Project:	Park Danforth			
Location:	Portland, ME			
Becker Job No:	3422

OBSERVATION REPORT

Cast in Place Concrete

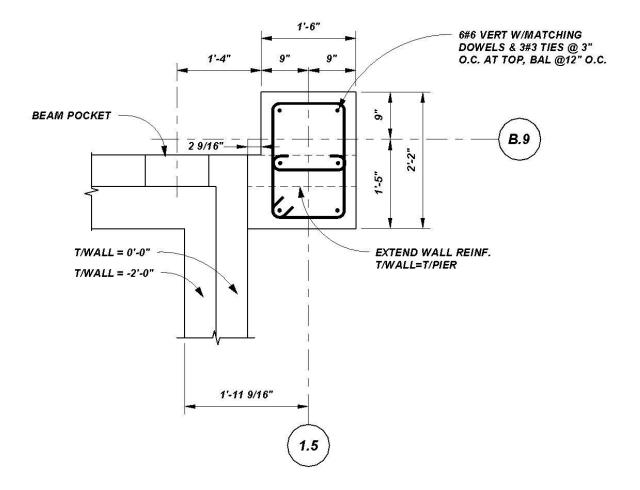
I discussed RFI-0063 with Andrew Pires form PC. Please see below for dimensional clarification for the connector wall off of pier B.9(1.5).
